キャリバー9T/9Uシリーズ仕様変更について

キャリアー9Tシリーズ仕様変更

Quantity	Cal. NO.:
Unit	9U17
Scale	Parts No.:
8 : 1	
Date	Name:
Drawn	Frame for Case
Checked	Drawing No.: 9U1700C0
Approved	
Material	General Tolerances
Heat Treatment	Dimensions
Hardness	Angles
Plating

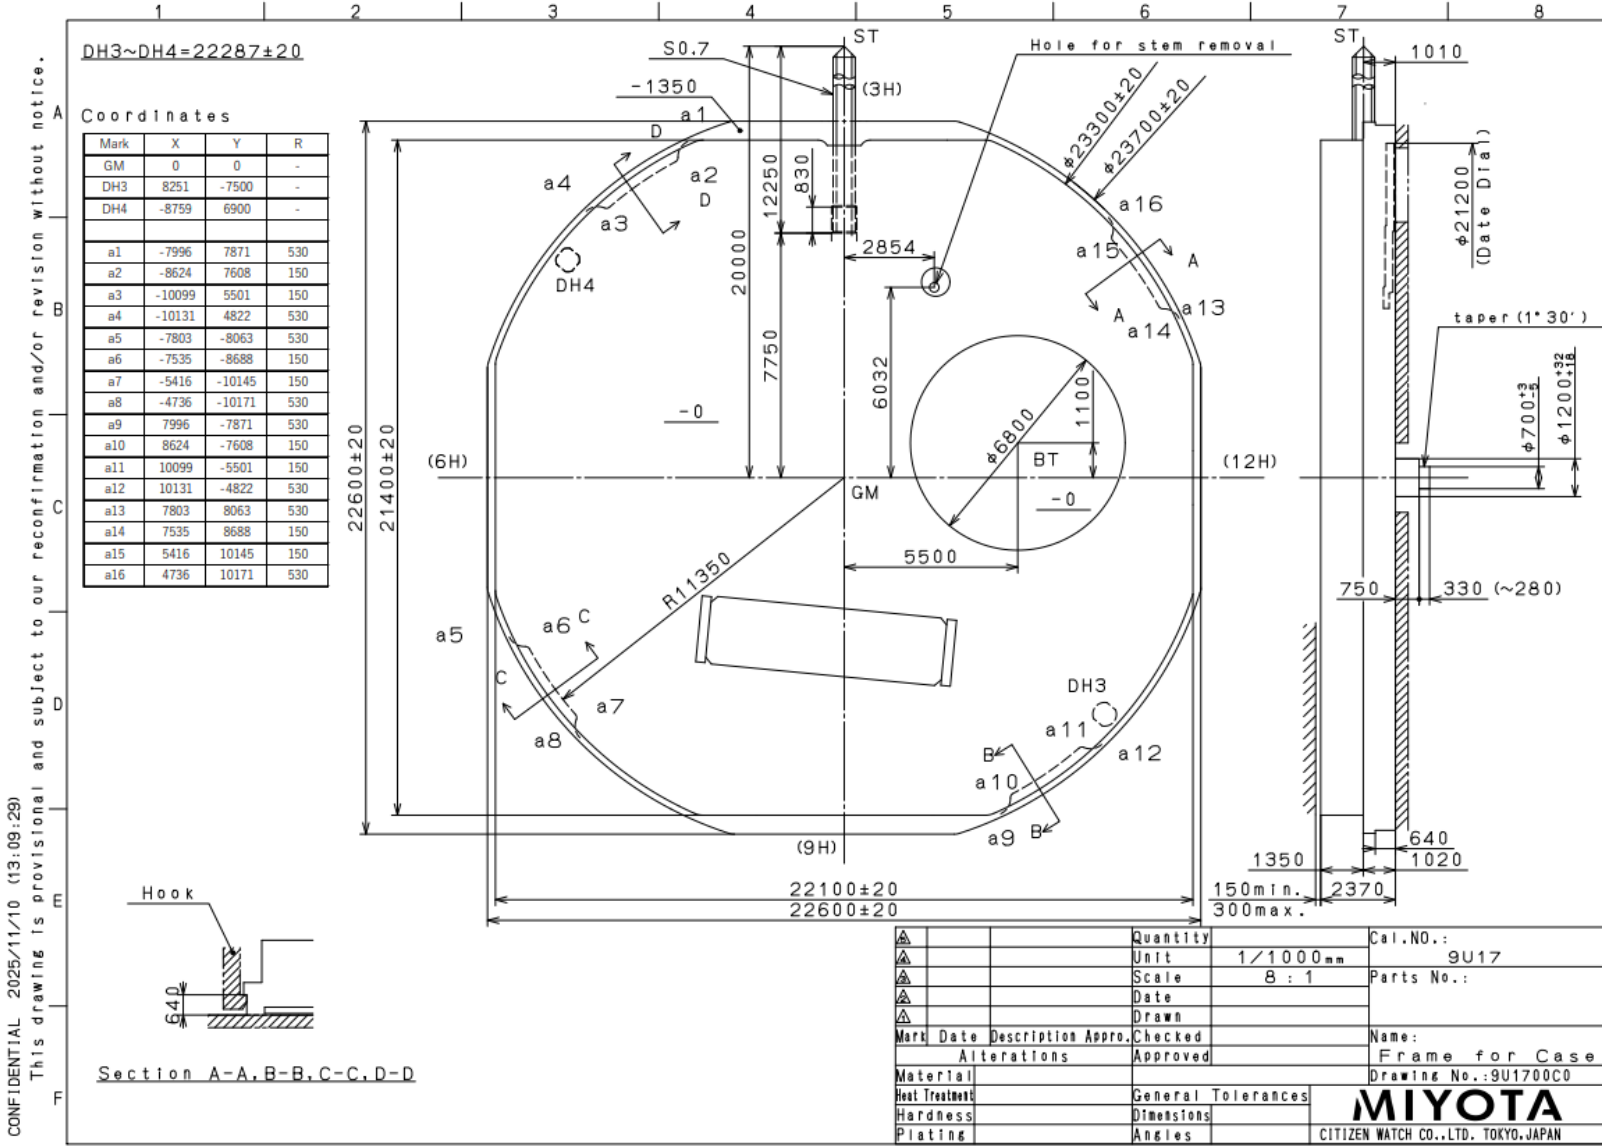
キャリアー番号	9T22 →9T25	9T15 →9T17	9T33 →9T35	9T13 →9T12
サイズ (変更なし)	6 3/4×8'''	6 3/4×8'''	6 3/4×8'''	6 3/4×8'''
針 (変更なし)	2針	2針	3針	3針
カレンダー (変更なし)	-	○	-	○
電池 (変更なし)	3年	2年	2年	2年
色	銀色	銀色	銀色	銀色

- 外装(ケース、針、文字板)に対しては互換性がありますので、そのまま使用可能です。
- 色のみ変更となります。

キャリバー 9U17 図面

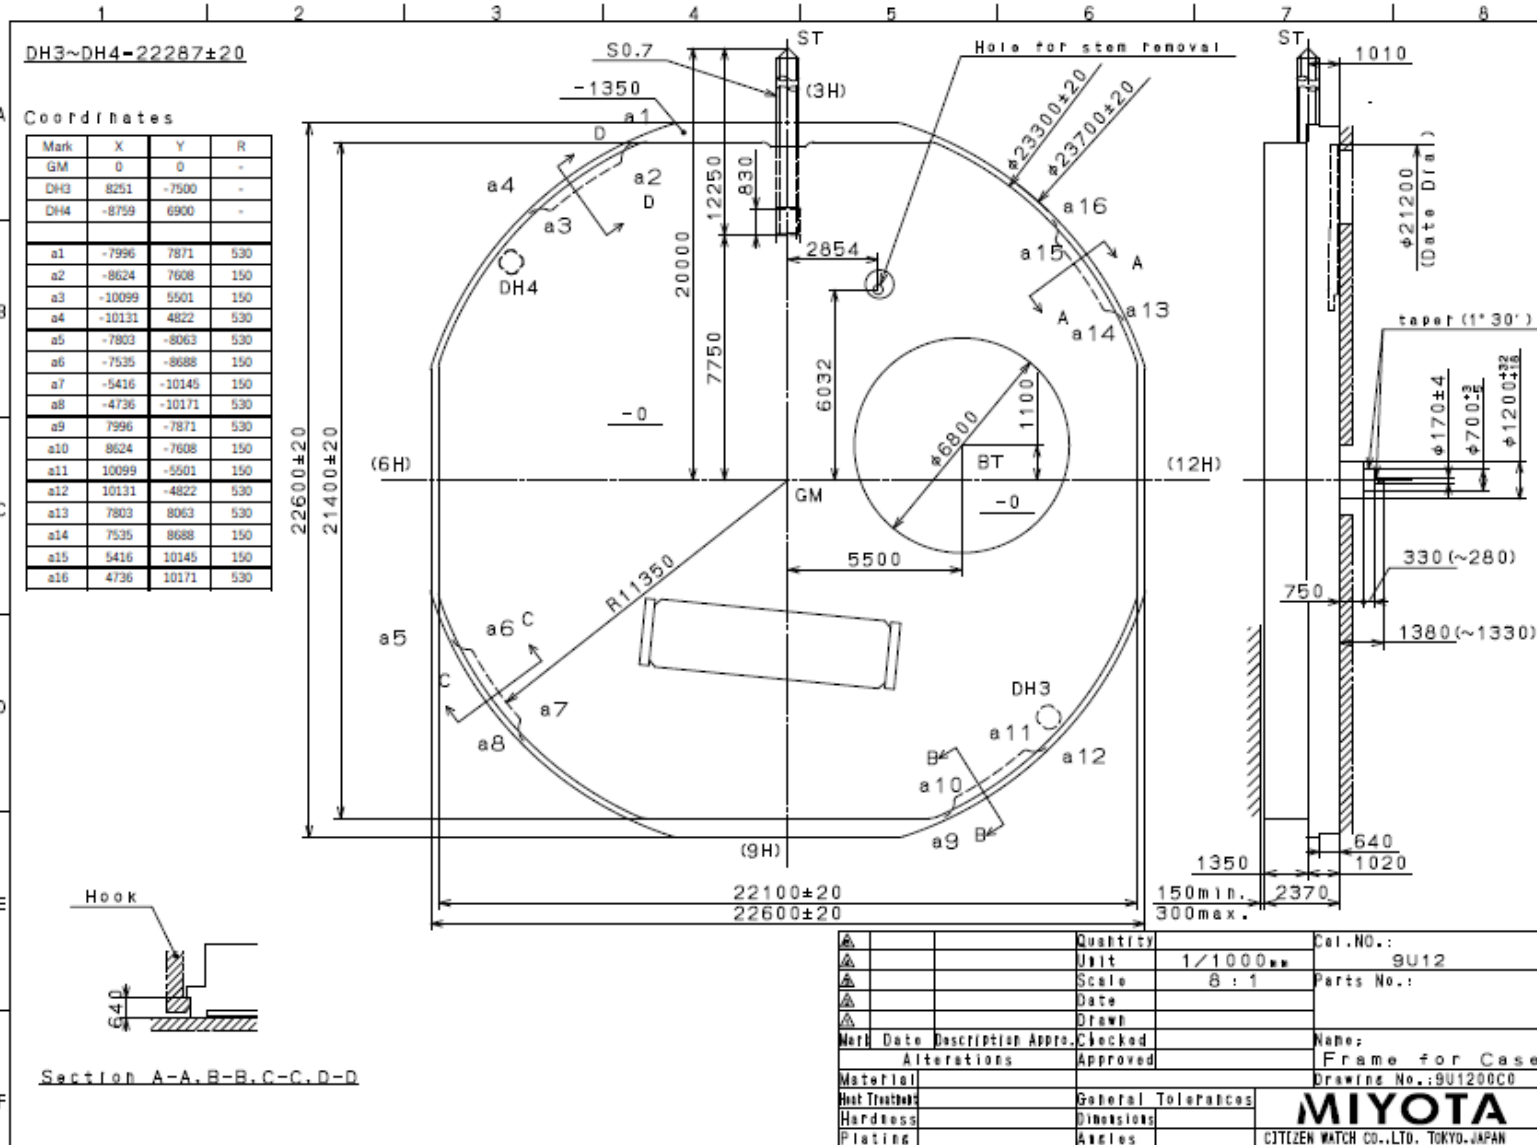
キャリアー番号	9U15 → 9U17	9U13 → 9U12
サイズ	10 1/2'''	10 1/2'''
針 (変更なし)	2 針	3 針
カレンダー (変更なし)	○	○
電池寿命	2年	2年
色	銀色	銀色

- 外装(ケース、針、文字板)に対しては互換性がありますのでそのまま使用可能です。
- 中枠のみ新しく設計する必要があります。設計に際しては次ページの図面を参照ください。
